Version 2

## Product Update: 2018 Odyssey Front Control Box OTA Software Update

Supersedes 20-059, Dated July 29, 2020, to revise the information highlighted in **yellow**.

Under REPAIR PROCEDURE – USB FLASH DRIVE, a note and image were added under step 10.

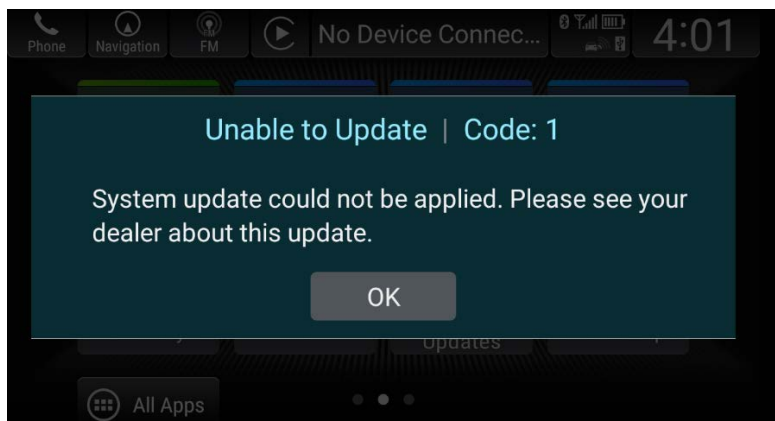
- If you encounter a message **Unable to Update | Code: 1** after seeing the image above, press OK and cycle the ignition.
